**CERTIFICATE OF APPROPRIATENESS**

**Property:** 1636 South Boulevard, Lot 13, Block 3, Edgemont Subdivision. The property includes a historic 3725 square foot two-story brick single-family residence and detached garage situated on a 15,980 square foot (94' x 170') interior lot.

**Proposal:** Alteration – Revision. In February 2014, the applicant was granted permission to install a new carport with a front facing brick arched vehicular entrance gate at the west side of the residence.

ROOF PLAN

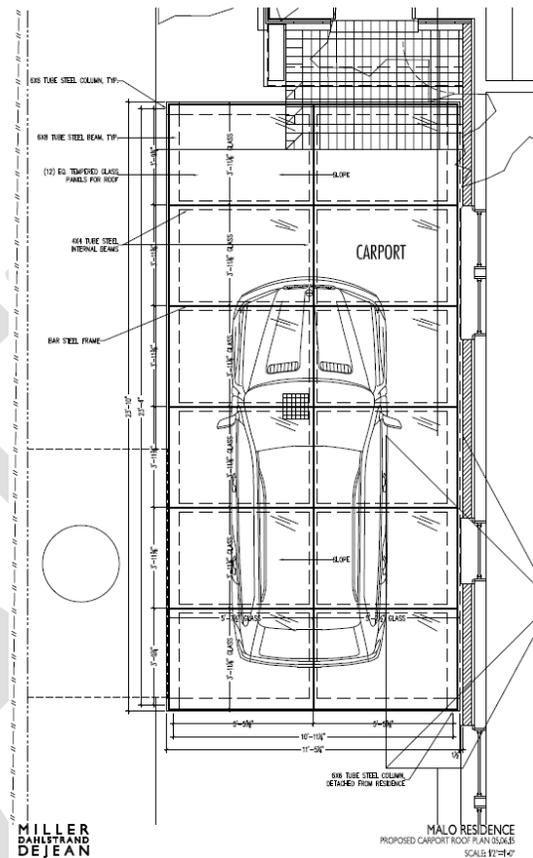
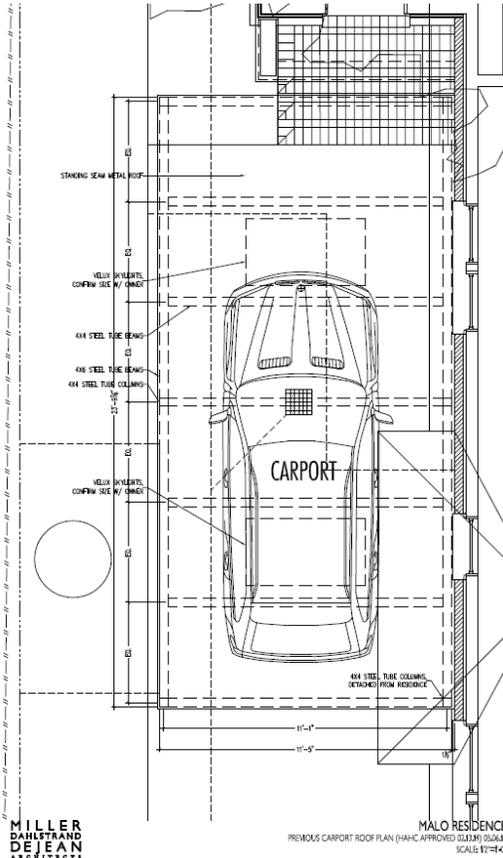
- The roof that will now be comprised of 12 tempered glass panels instead of a standing seam metal roof with two skylights
- The previously approved footprint of the carport will not be altered
- The proposed brick arch vehicular entrance will be revised to no longer incorporate an archway. The gate will now be attached to a portion of the existing buttress.

**Roof:** The proposed roof of the carport will be comprised of 12 panels of tempered glass and will have a minimal slope to the west. See drawings for more detail.

Carport: Revisions to the carport include altering the previously approved 6 panel standing seam metal roof with two skylights to a 12 panel tempered glass roof. Carport will maintain its steel frame. The decorative wrought iron work has also been eliminated. Gutters and downspouts and size to remain the same. It still remains detached from the existing house. See drawings for more detail.

### FIRST FLOOR PLAN

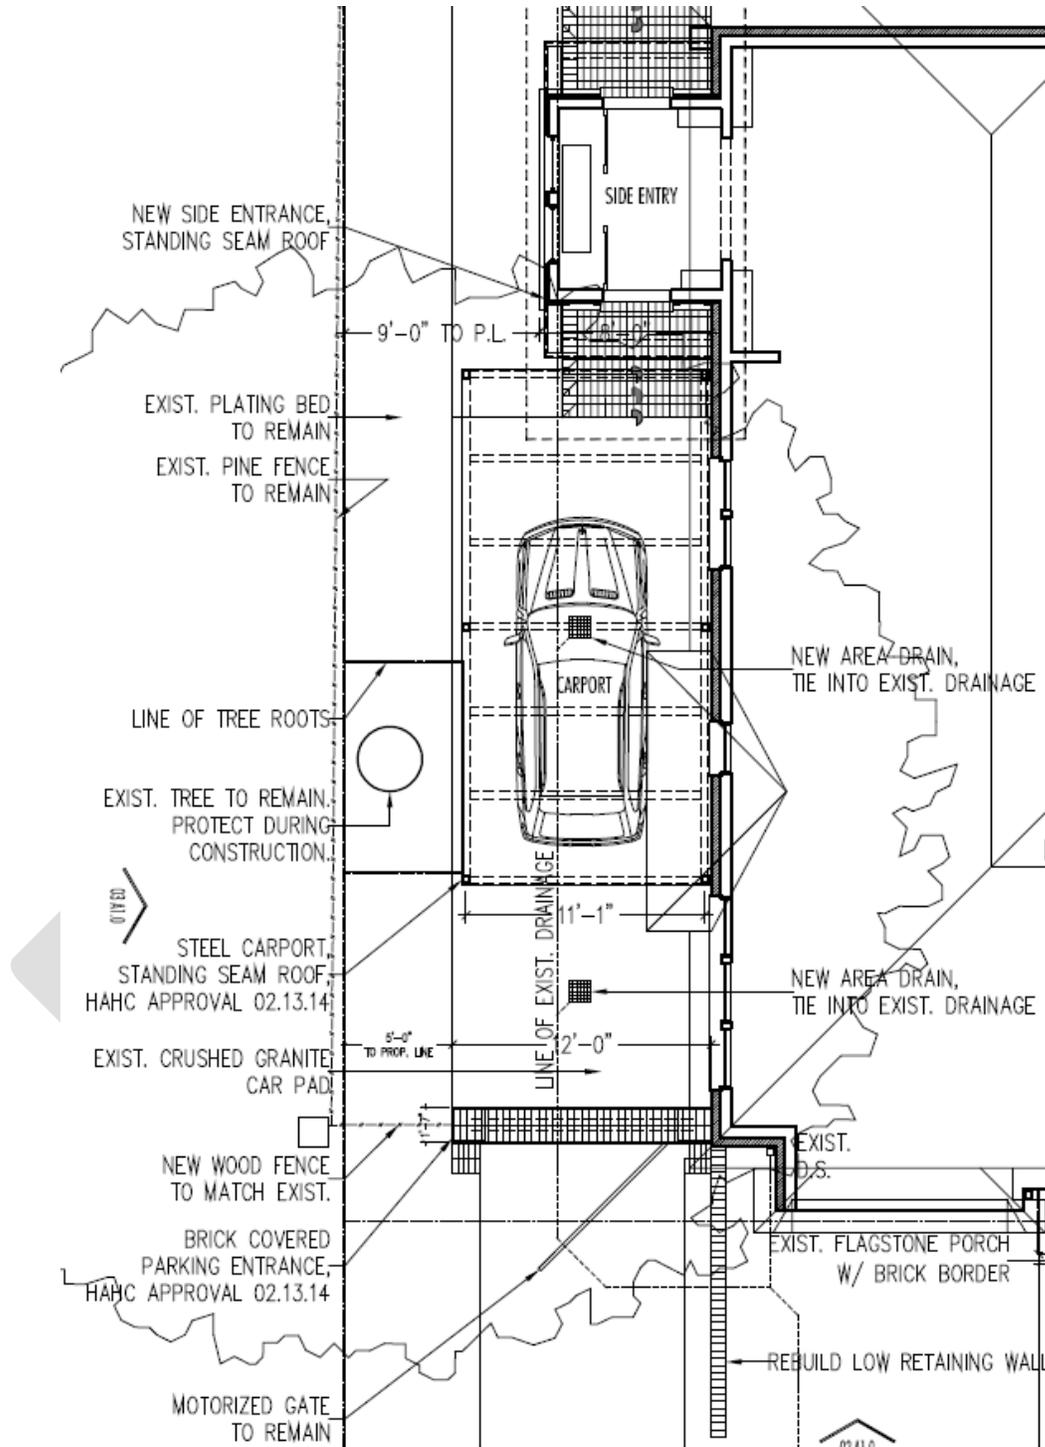
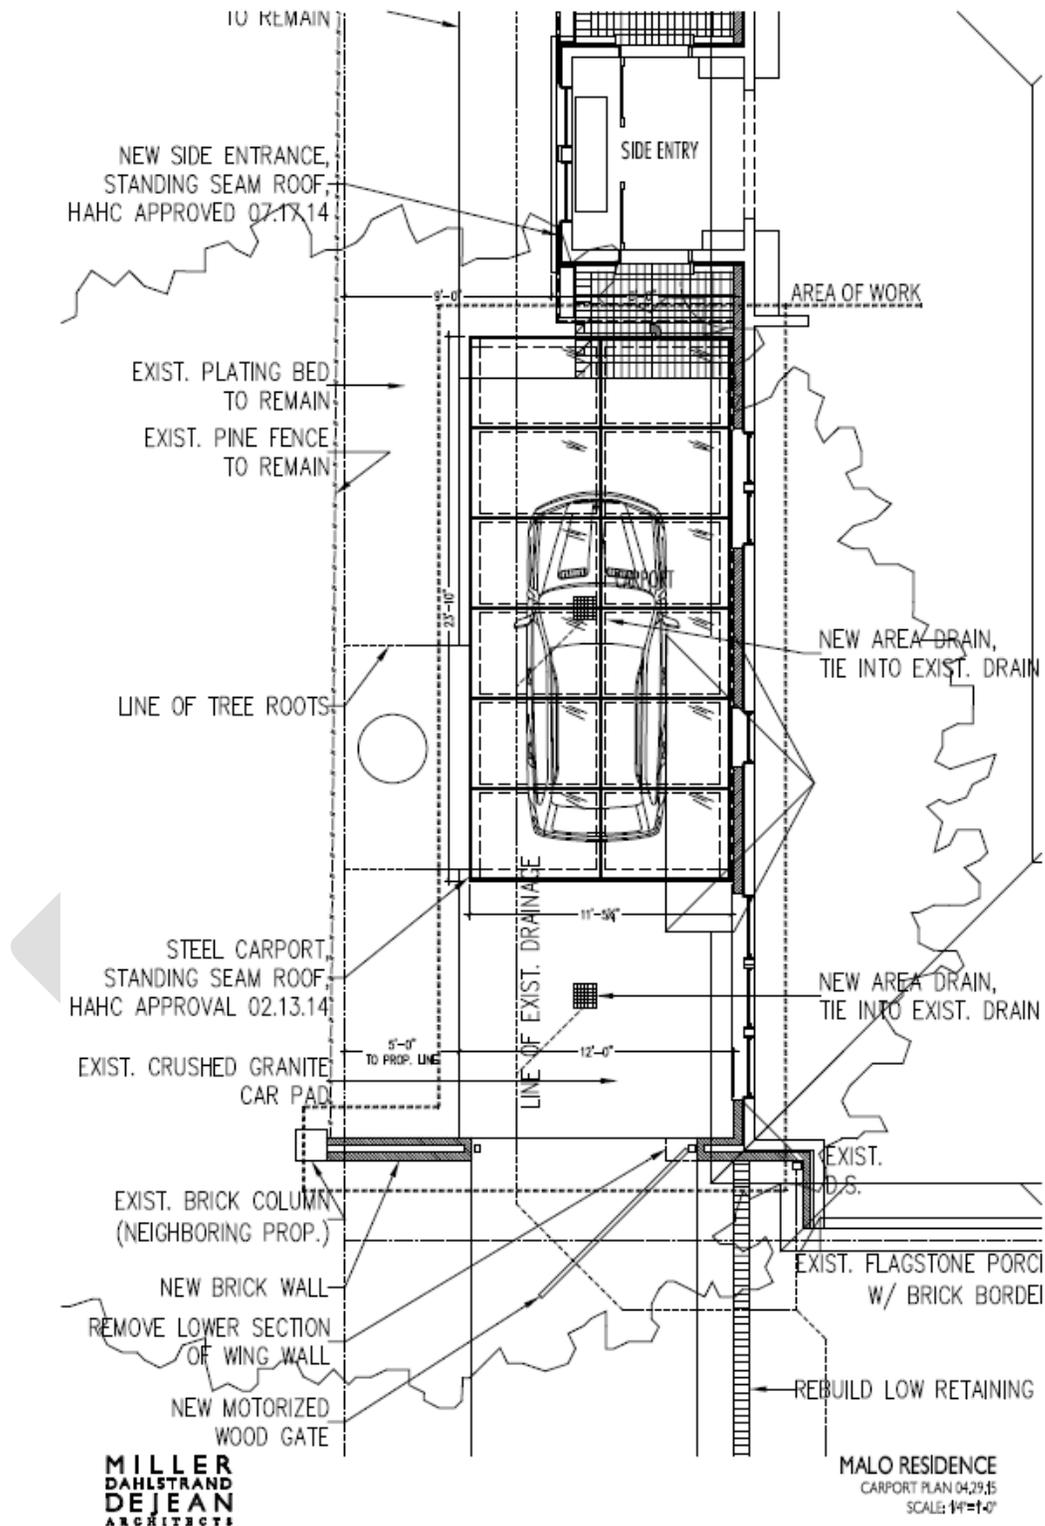
**Shape/Mass:** Carport: The approved footprint dimensions of the carport will not be altered. The steel frame carport will have a width of 11'-5¼" and a depth of 23'-10". The carport will have a height of 12'. The roof of the carport will be supported by four 4" x 4" square tube columns. See drawings for more detail.

**Setbacks:** The proposed vehicular entrance gate will be located 38'-6" from the front property line. The proposed carport will be located 50'-8¾" from the front property line and 11'-2¾" from the proposed vehicular entrance gate. The carport will be located 5'-5¼" from the west property line. The proposed gate wall will extend 9 5/8" over the property line to an existing brick column.

GATE ATTACHMENT DETAIL

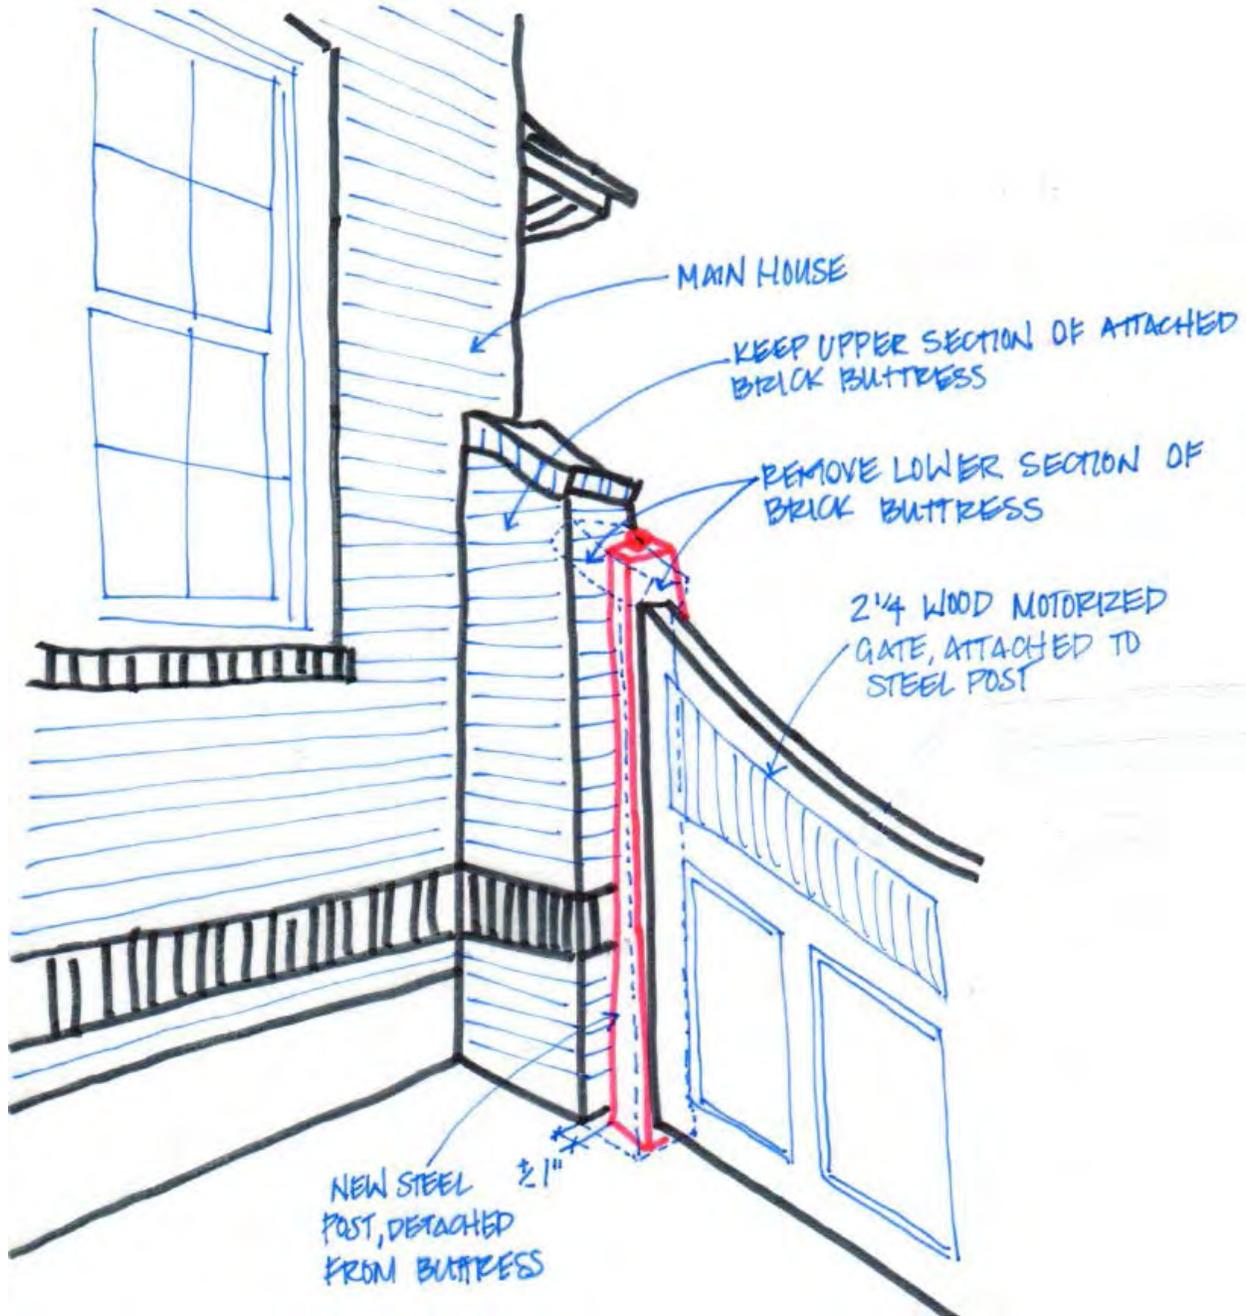
Entry Gate: The previously approved entry gate will be revised and will no longer include the brick arch. As currently proposed, a lower section of the brick buttress attached to the house will be removed and a steel post and wood gate will be installed, both detached from the buttress. The steel post will be installed 1" from the remaining portion of the buttress. The total width of the gate will be 9'-0" (with a width of 9'-10" including the posts). The wood gate will have a 'U' shape design with a maximum height of 6'-6½" and a minimum height of 5'-5". A 7'-9" brick wall will extend from the wood gate to an existing brick column. The brick wall will have a maximum height of 8'-0" and a minimum height of 7'-2". The brick wall will be 1'-0" thick. See drawings for more detail.

**Proposed Alterations:** Entry Gate: The proposed brick arch vehicular entrance will be revised to no longer incorporate an archway. The gate will now be attached to a portion of the existing buttress and will now include a lower brick wall with motorized wood entrance gate. The tallest part of the fence will be no more than 8'-0" in height. New brick wall to match existing details from attached wing wall. See drawings for more detail.
